PG&E Letter DCL-03-047

Docket No. 50-275, OL-DPR-80
Docket No. 50-323, OL-DPR-82
Diablo Canyon Units 1 and 2
Response to NRC Request for Additional Information Regarding License Amendment Request 02-03, "Spent Fuel Cask Handling"

PG&E Response to NRC Request for Additional Information Regarding License Amendment Request 02-03, "Spent Fuel Cask Handling"

Figure 1-1-1
Spent Fuel Cask Handling Route
(excerpted from DCPP FSAR Update, Figure 9.1-7)

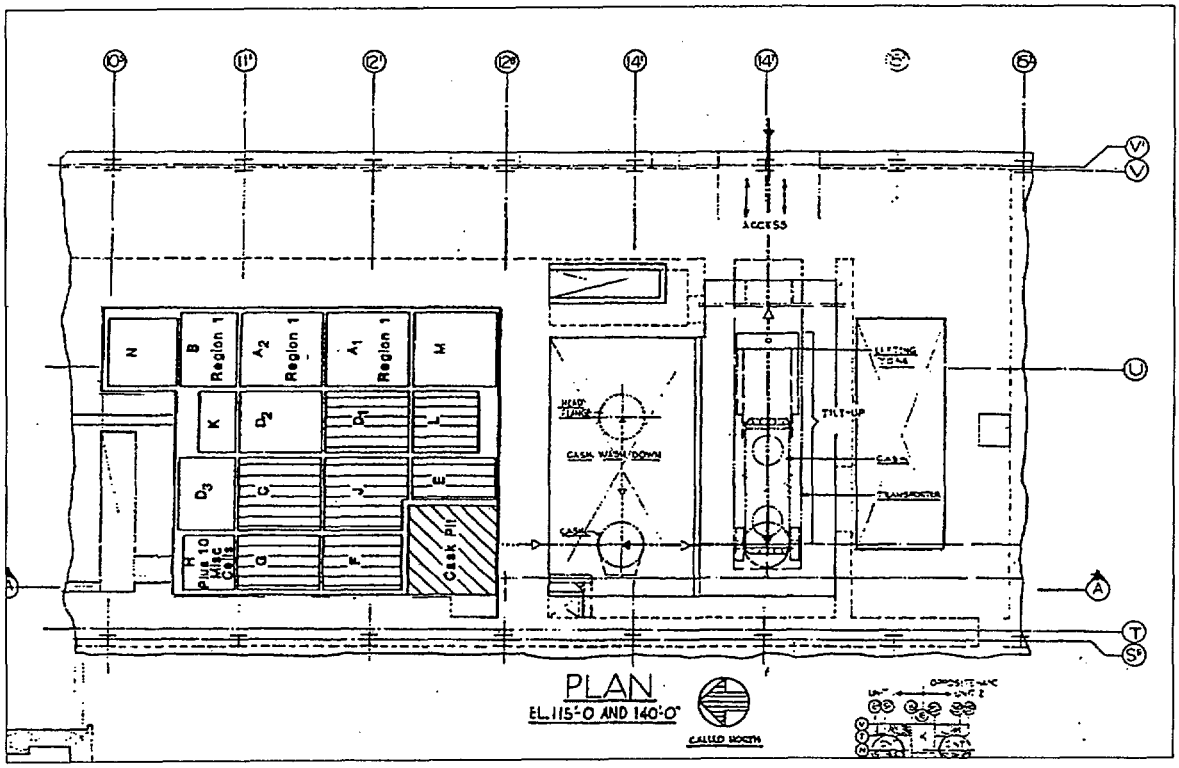
The proposed LAR requires revisions to plant procedures covering the handling of heavy loads. What procedures need to be revised and updated to implement the transfer cask/MPC operation? What training if any will be conducted to ensure personnel understand the new procedures and when will the training be completed? Additionally, if any other procedures require revision what procedures will be revised and what training will be conducted and when?

There are two commonly discussed "exclusion" areas or zones in the SFP area of the FHB/AB. The exclusion zone to be eliminated, is associated with the requirement to verify there is no spent fuel within storage rack regions depicted in FSAR Update, Figure 9.1-6 as "spent fuel cask exclusion zones," before a spent fuel cask can be moved north beyond Column line $12^{\underline{9}}$ or South beyond column line $23^{\underline{1}}$. This requirement was in DCPP Technical Specification 3.9.13 until it was relocated to FSAR Update, Section 9.1.2.3.1 as part of License Amendments 135/135. Figure 1-1-1 depicts the Unit 1 configuration of the zone as excerpted from the FSAR Update figure. Note the striped storage rack modules adjacent to the cask recess area ("cask pit"). This zone restriction is currently implemented by a specific provision under FHB crane operating restrictions in IDAP MA1.ID14. Figure 1-1-2 depicts the Unit 1 configuration of the area as excerpted from the FSAR Update figure. Note that the cask is excluded north beyond Column line $12^{\underline{9}}$ when fuel is present in the zone. Upon approval of this LAR, the restriction will be removed and nuclear fuel may be present in these storage

rack locations during cask handling operations. The response to NRC Question 3-2 discusses the basis for elimination of the spent fuel cask exclusion zone.

Figure 1-1-2
(excerpted from DCPP FSAR Update Figure 9.1-3)

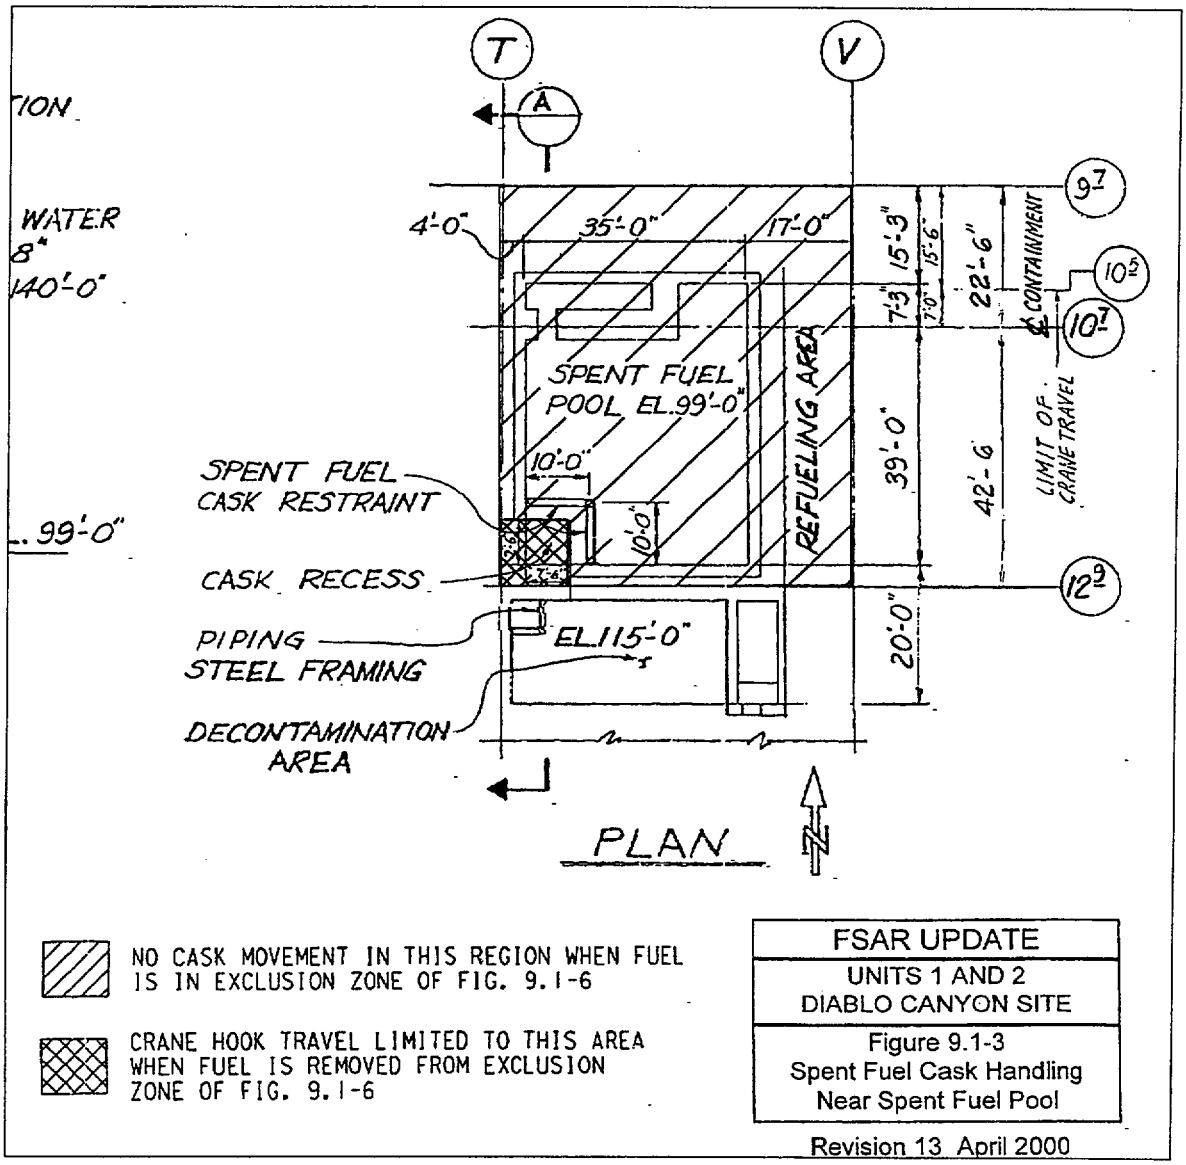
The Diablo Canyon Power Plant (DCPP) license amendment request to revise the DCPP updated final safety analysis report (UFSAR) regarding its control of heavy loads program proposes to eliminate the spent fuel cask exclusion zone. The UFSAR restricts cask movement to the portion of the spent fuel pool which is over the cask recess area. The defense-in-depth approach within NUREG-0612, "Control of Heavy Loads at Nuclear Power Plants," states that despite the increase reliability of the overhead handling system licensees should (1) provide sufficient operator training, handling system design, load handling instructions, and equipment inspection to assure

For clarification, PG&E does not intend to handle a spent fuel cask over any area of the SFPs other than the cask recess area as depicted in DCPP FSAR Update, Figure 9.1-3. The DCPP Control of Heavy Loads Program prohibits movement of all heavy loads over the SFP fuel storage racks unless specifically authorized by written procedures reviewed and approved by the PSRC. This program requirement is implemented in plant administrative controls by a "Heavy Load Exclusion Area". PG&E will not move the cask over the spent fuel storage racks, and the exclusion area over the fuel will not be eliminated.

Figure 1-4-1
Extension Link

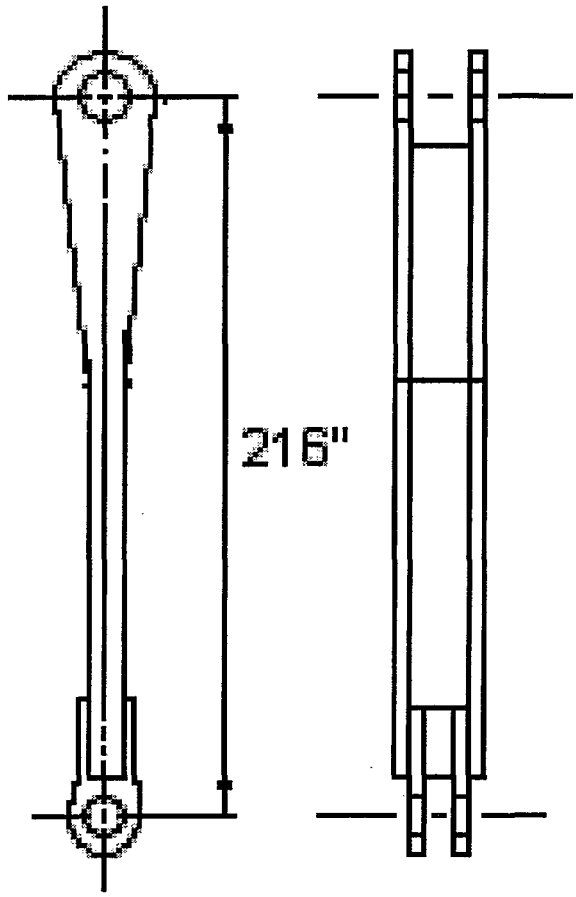
The auxiliary lift provides the overhead handling system with redundancy when used in heavy load handling operations. However, the submittal does not describe the design, testing, or inspection criteria for the auxiliary lift. Provide the design, testing, and inspection criteria applicable to the auxiliary lift and a description of the proof testing to completed at the manufacturers facility on the auxiliary lift to verify its ability to perform its intended function prior to the checking and testing performed at the place of installation.

The rigging between the auxiliary lift and transfer cask lift yoke is designed in accordance with applicable provisions of ASME B30.9 for the slings and ANSI N14.6 for the steel extension links (see Figure 1-4-1) used only for handling between the CWA and RSA locations. The rigid extension links (approx. 1,800 lb. ea.) are used in series with each sling from the auxiliary lift lifting beam to allow the sling to control the vertical displacement of the load during load transfer. Since the rigging to the cask lifting yoke is not redundant, a 10-to-1 factor of safety was used to select the slings per NUREG-0612 guidance, and the extension links are designed as special lifting devices per ANSI N14.6.

Figure 1-5-1
Fuel Handling Crane Load Paths

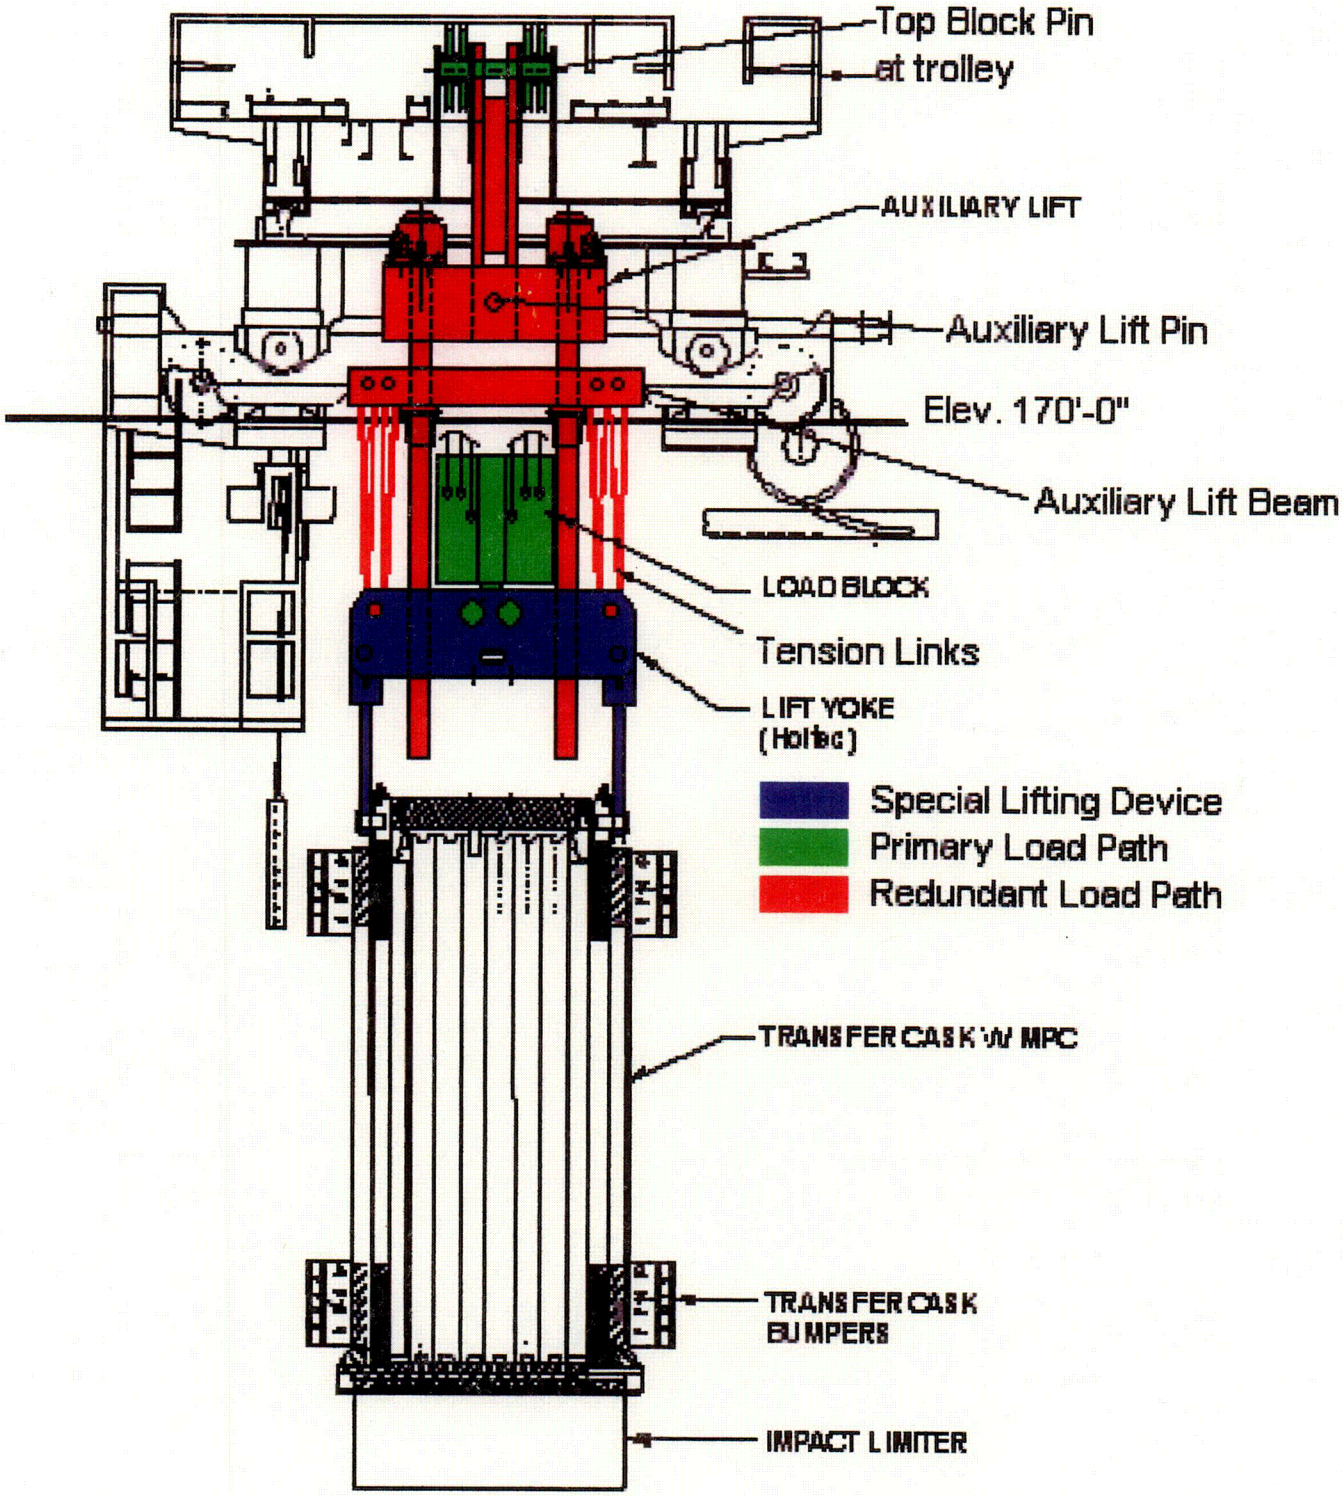
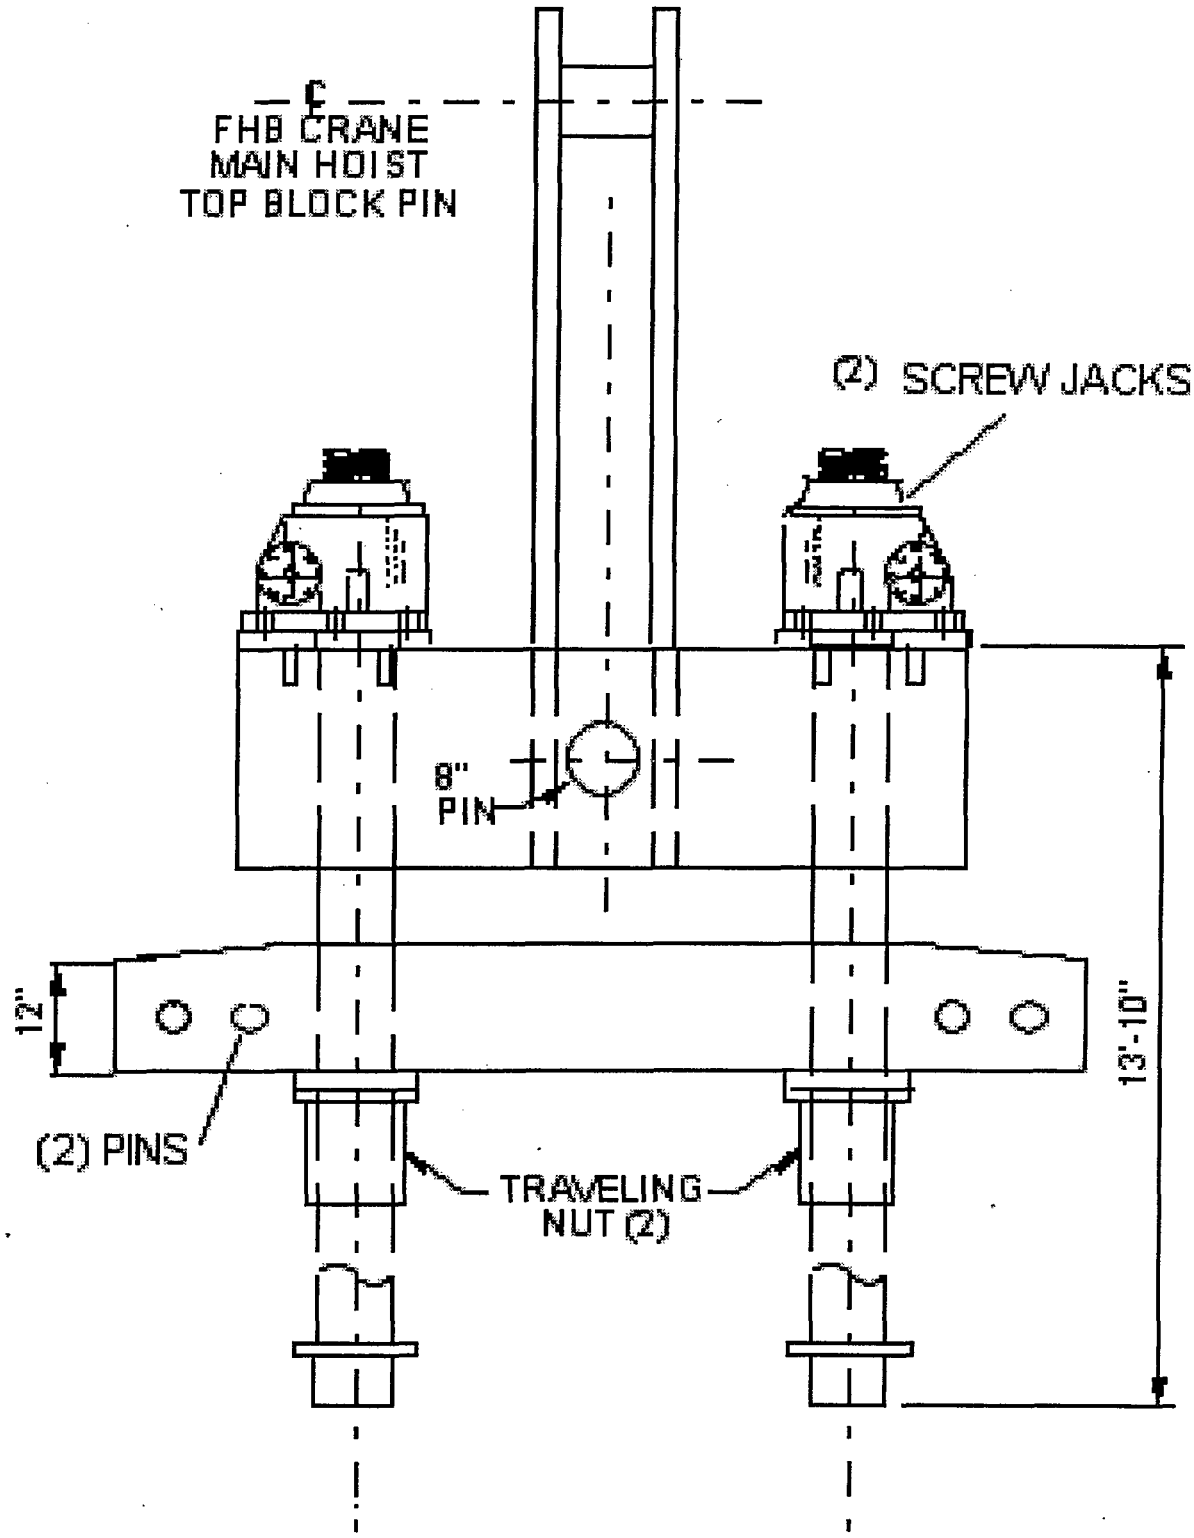
Although the original crane design was described in the December 5, 1984, NUREG-0612 submittal, describe how the auxiliary lift is design to move in the horizontal and vertical direction with respect to the crane bridge and trolley?

The auxiliary lift is an integral part of the crane trolley and moves horizontally with the crane trolley. Thus, east-west horizontal movement is accomplished by trolley movement along the girders of the FHB crane. North-south horizontal movement is accomplished by bridge movement along the FHB structure runway. Vertical movement of auxiliary lift lifting beam (approximately 96 inches) is provided by the rotation of the screw jacks. Coordination of the main hoist and auxiliary lift vertical movement is further described in response to NRC Question 1-6. During cask handling operations, the upgraded control system design of the FHB crane will be capable of prohibiting simultaneous, multi-axis load movement. One exception is the upending/downending operation of the transfer cask in the RSA on the cask transport frame where simultaneous trolley and main hoist operation is necessary.

The auxiliary lift is structurally attached to the trolley using the main hoist top block pin that also supports the main hoist sheaves.

See enclosed sketches of the trolley and auxiliary lift (Figures 1-5-1 and 1-5-2).
